NOTICE OF ADOPTED AMENDMENT

SUBJECT: City of Wilsonville Plan Amendment
DLCD File Number 009-05

Villebois Village Master Plan amendments to revise Chapter 3: Parks & Open Space /
Off Street Trails and Pathways; and Chapter 4: Utilities

AN ORDINANCE ADOPTING AN AMENDED CHAPTER 3 – PARKS AND OPEN SPACE/OFF STREET TRAILS AND PATHWAYS AND CHAPTER 4 –UTILITIES OF THE VILLEBOIS VILLAGE MASTER PLAN

Palermo Park - Pond E2
 May 3, 2006

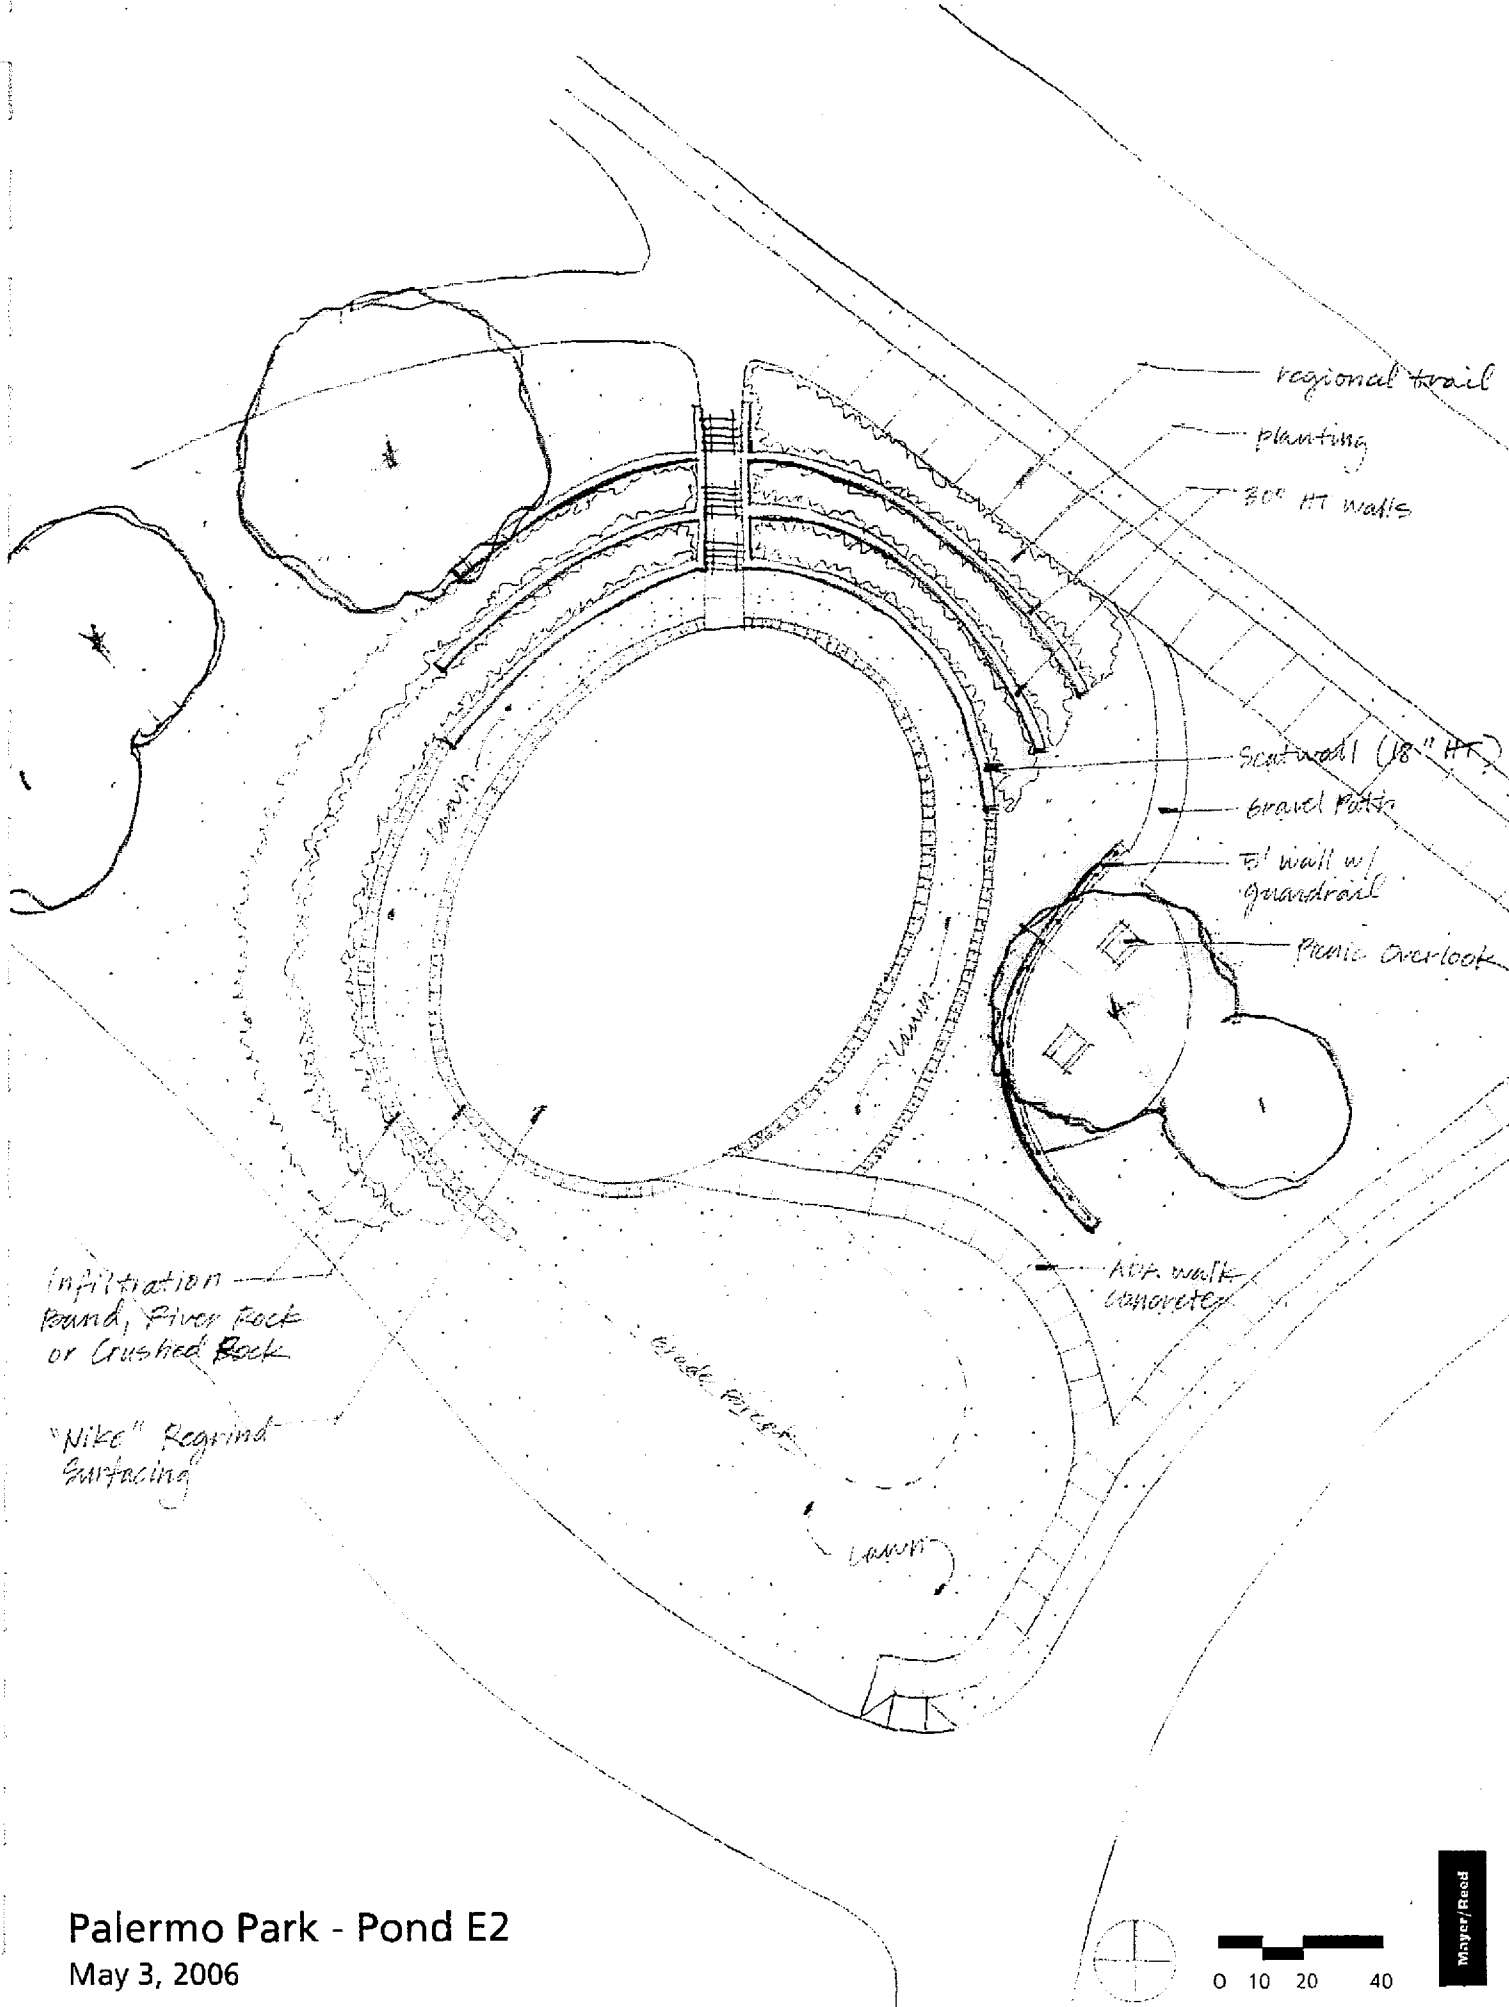
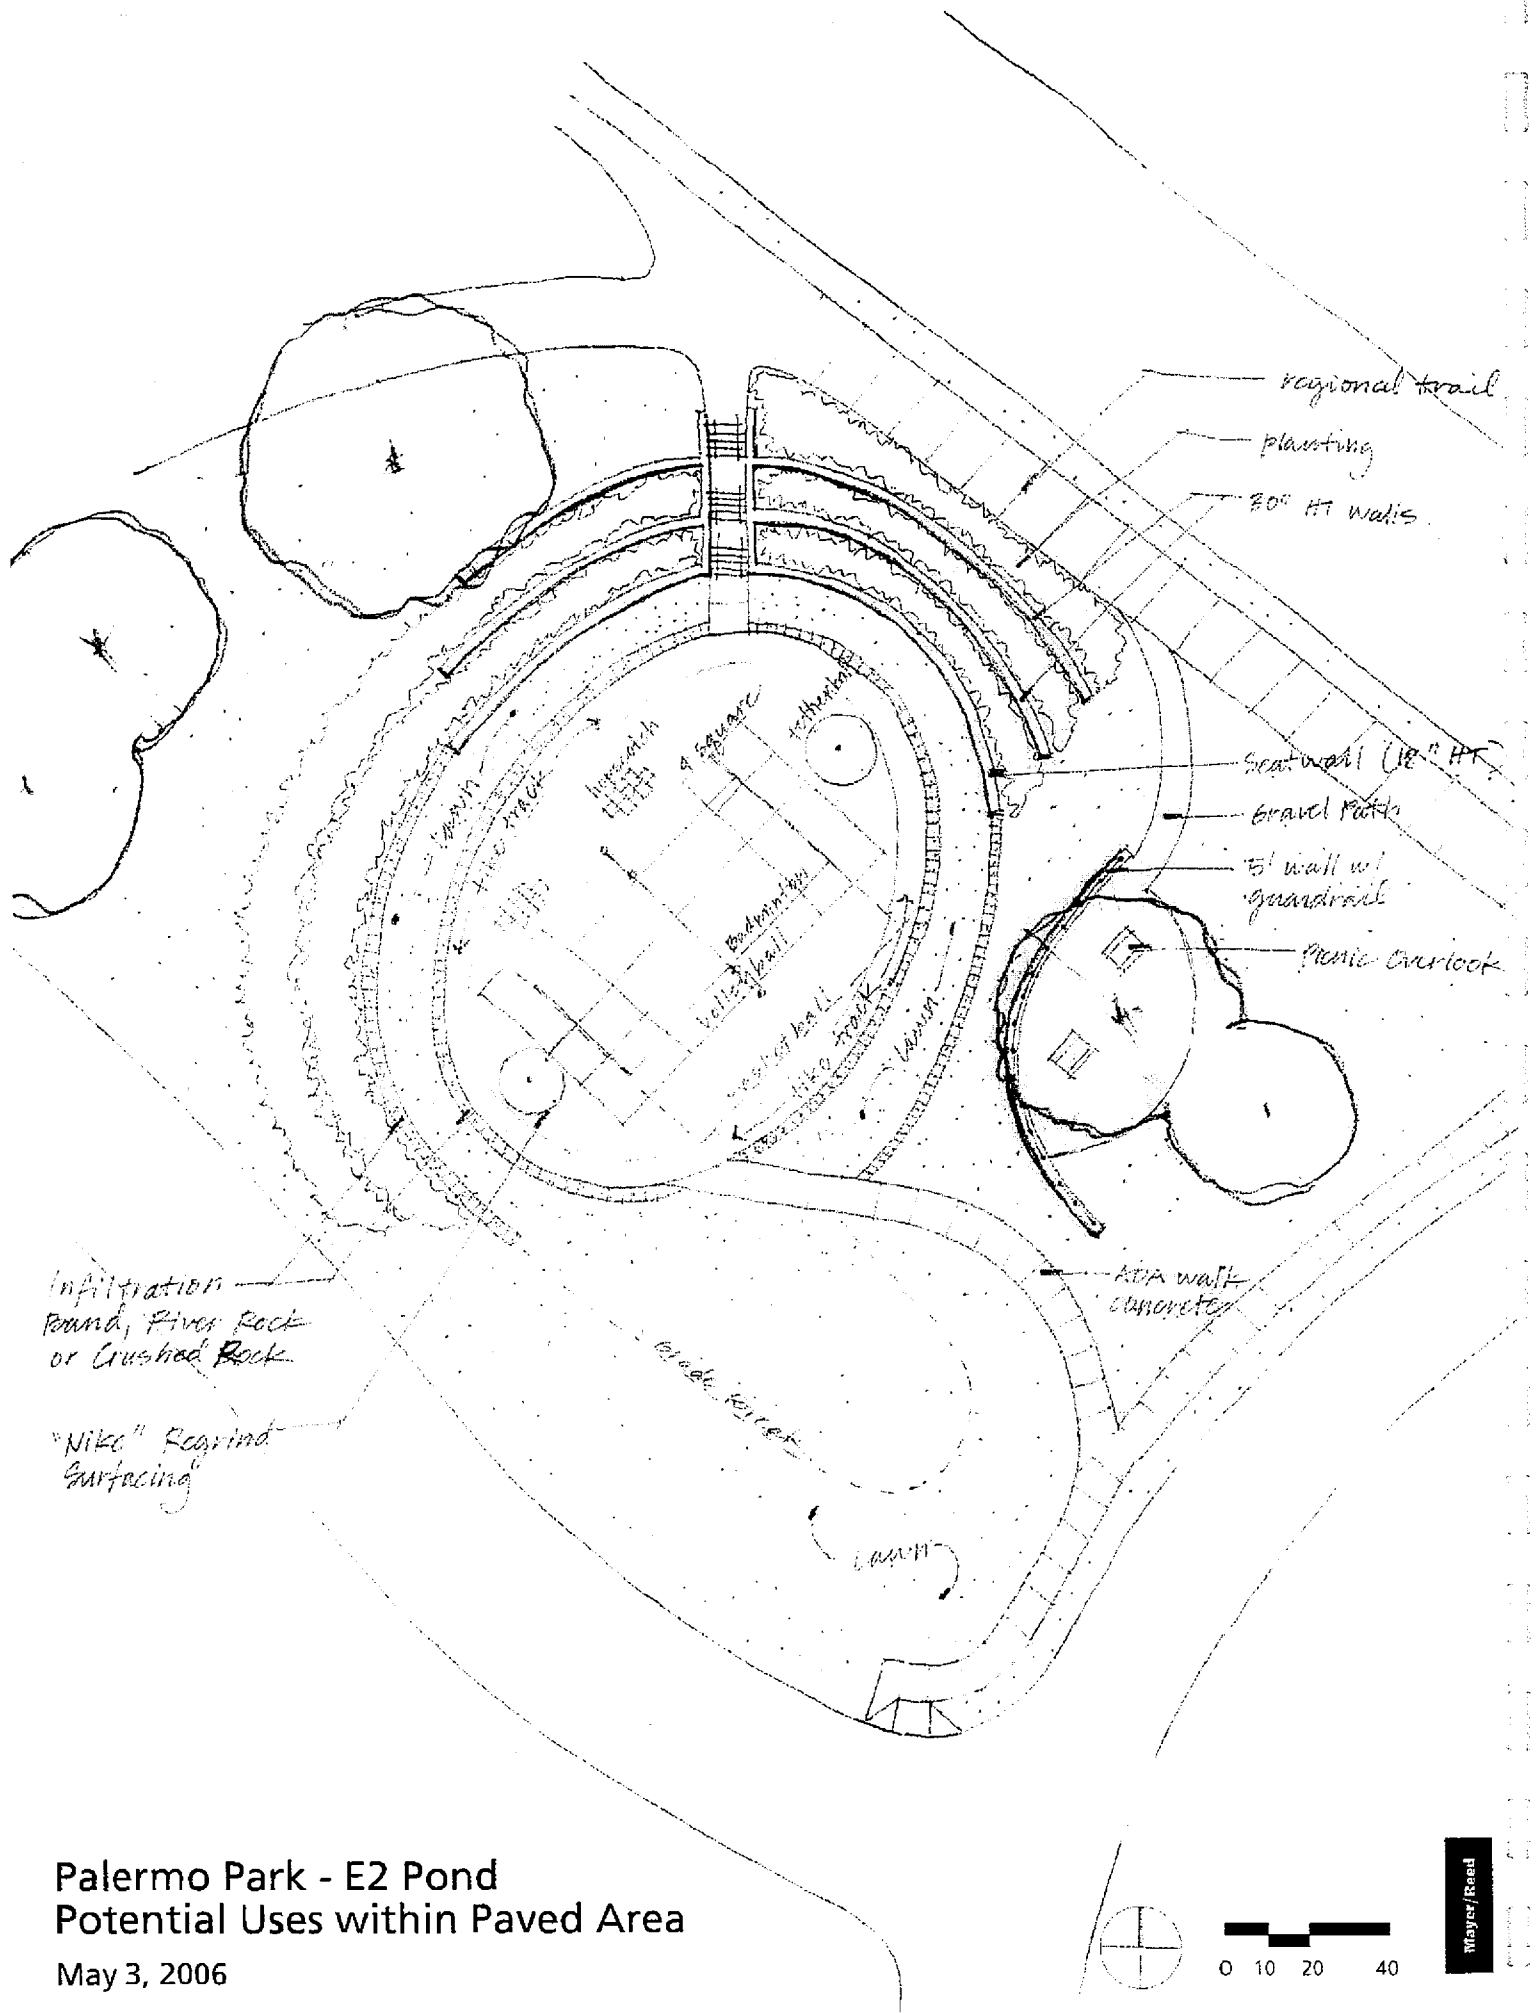
As an additional amenity, an overlook with picnic tables beneath an existing tree on the SE corner is illustrated. This overlook has a view into the play court and is an invitation for neighbors to spend more time and observe activities taking place in the play court. The overlook will require a 5' retaining wall (with a guardrail) to preserve the existing tree.

To set off the form of the oval play court and to ensure improved drainage, two gravel infiltration strips are located along the perimeter of the paved surface. These strips will help to drain the surface from its center and will connect

to the proposed outlet. Between the two gravel strips is an 8' lawn area to soften the appearance of the play court. The higher side of the site is framed by three curved retaining walls that are needed to hold the grades enough to meet the desired stormwater capacity. The lower wall is an 18" high seat wall.

Figure 5A

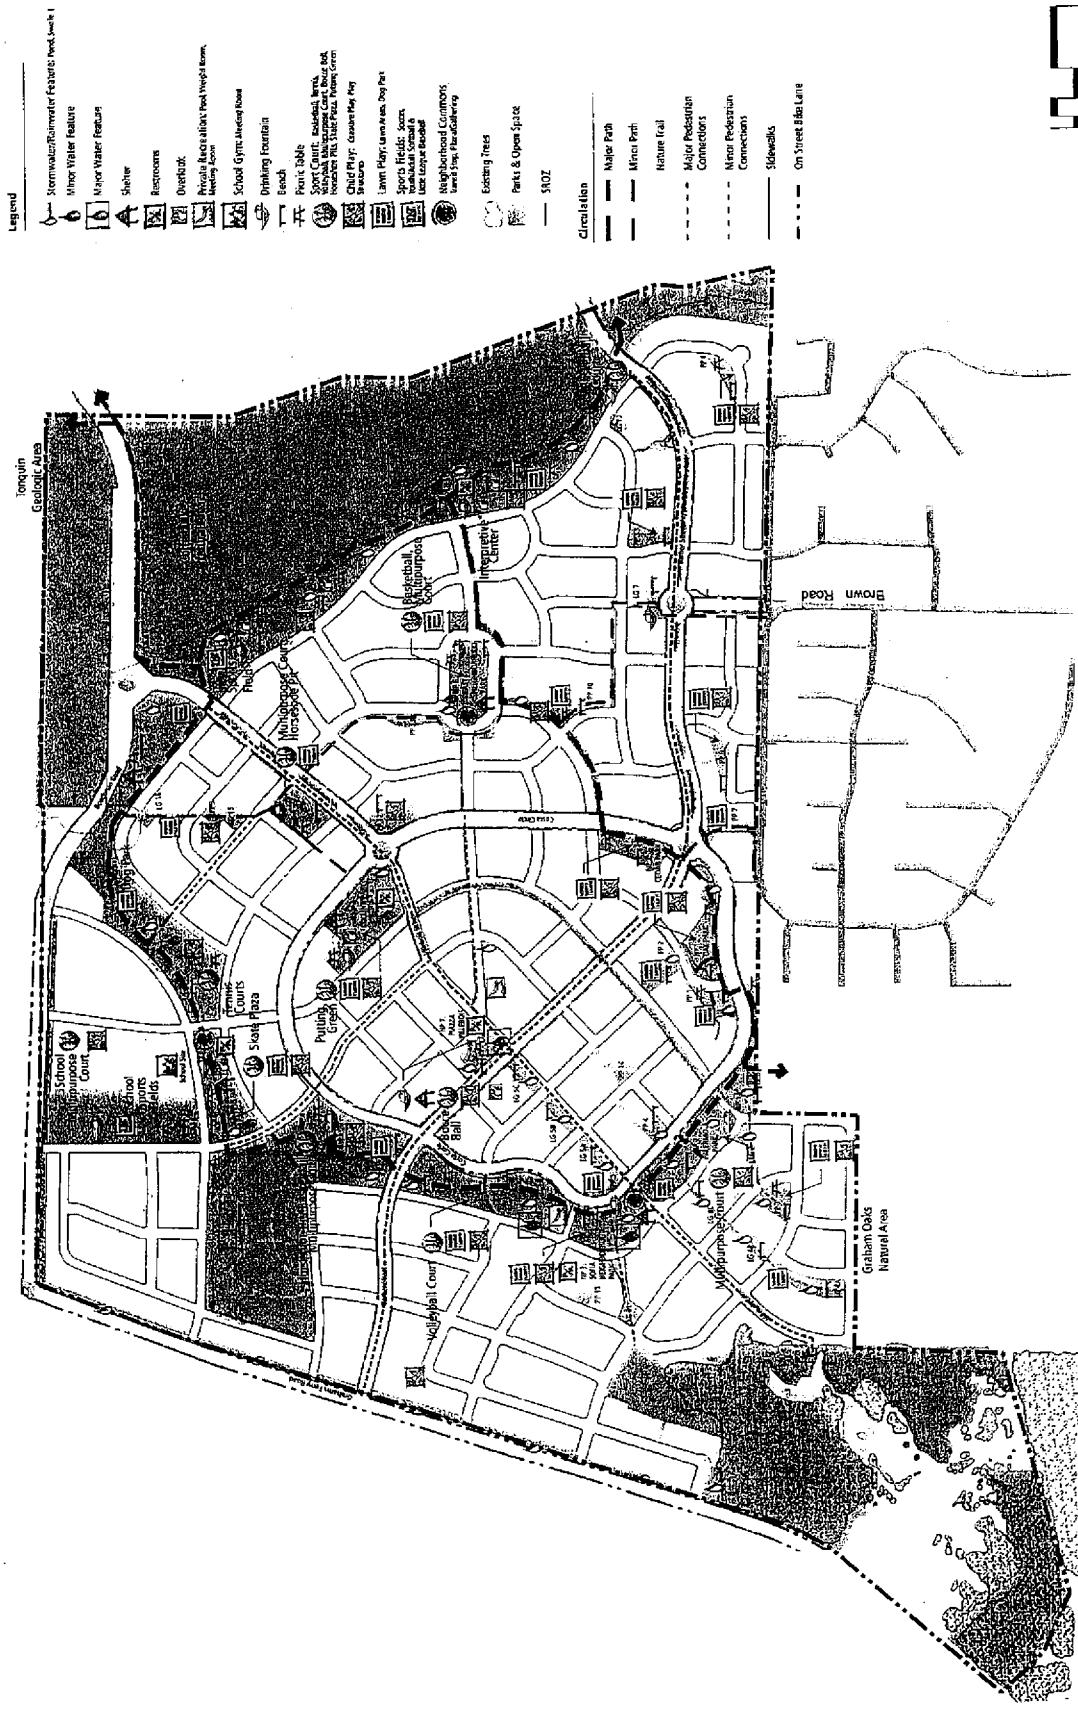
A Child Play area has been added to the southwestern region of SAP North in the area previously identified as deficient in child play uses. A child play icon has been placed in the vicinity of the bend in SW Salzburg St. and can be seen on Figure 5A of the Master Plan. This revised Figure is provided with this memorandum. The square footage of this park will be established with SAP North and the subsequent PDP for that area. If further assurance of this park is necessitated, an Implementation Measure can be drafted to add to Chapter 3 – Parks and Open Space, directing the creation of the pocket park including the child play feature.
